■CAB MOUNTING

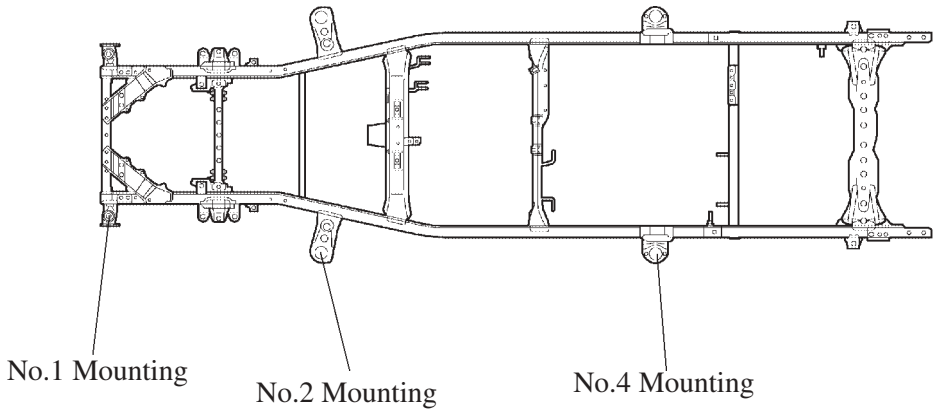
The rubber cushion of the cab mounting have been optimized in order to improve the vehicle's riding comfort and to reduce noise and vibration. In particular, on the double-cab model, the No. 3 cab mounting that was provided on the previous model has been discontinued to reduce the droning noise. At the same time, on the double-cab model, a share-type cushion has been provided in the No. 2 and No. 4 mountings to improve the vehicle's riding comfort and to reduce both noise and vibration.
